February 25, 2022

The Cottonwood Sand Mine Project (project) is located in the unincorporated portion of the County, in the Valle De Oro Community Planning Area. The Project proposes to convert the two golf courses within the Cottonwood Golf Club to a sand mining operation that would be conducted in three phases over 10 years. Approximately 214.4 acres of the approximately 280-acre site are proposed for extractive use.

Local Agencies and Districts

D-A4 – San Diego Air Pollution Control District

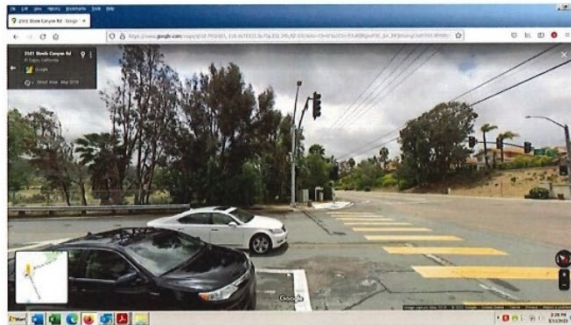
The 440 ADT increase in Heavy Truck traffic through the Willow Glen Drive/Steele Canyon Road intersection (traveling eastbound) exponentially increases the existing life safety hazard.

- a) Line of Sight Hazard at Steele Canyon Road:

D-A5-14 Submitting documentation that intersectional sight distance per County Public Road Standards 6.1.E can be met for each of the proposed access points along Willow Glen Drive would be a condition of Project approval. Additional Project conditions may be added depending on the information provided.
